**FINDINGS AND RECOMMENDATION  
OFFICE OF PLANNING AND ZONING  
ANNE ARUNDEL COUNTY, MARYLAND**

**CASE NUMBER:** 2023-0117-V

**PREPARED BY:** Sara Anzelmo  
Planner

The applicants are requesting a variance to allow dwelling additions (two-story addition and a covered porch<sup>1</sup>) with less setbacks<sup>2</sup> and buffer than required on property located at 502 Bayberry Drive in Severna Park.

PROPOSED SITE PLAN  
SCALE 1" = 40'

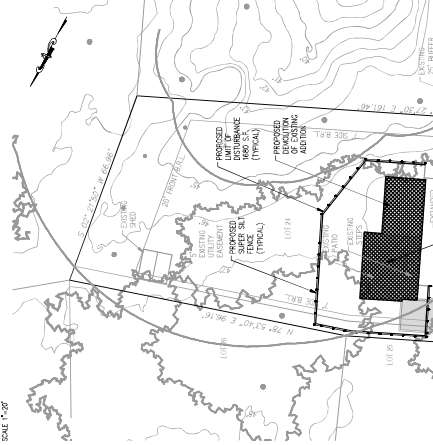
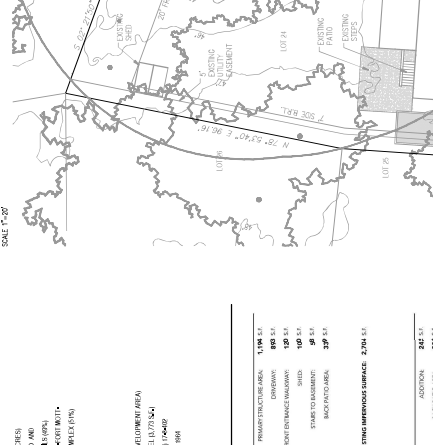
Based upon the standards set forth in § 18-16-305 of the Code under which a variance may be granted, this Office recommends *approval* of a Critical Area variance to § 17-8-301 to allow construction of the proposed two-story dwelling addition and covered porch with disturbance to the expanded buffer as shown on the site plan submitted by the applicant.
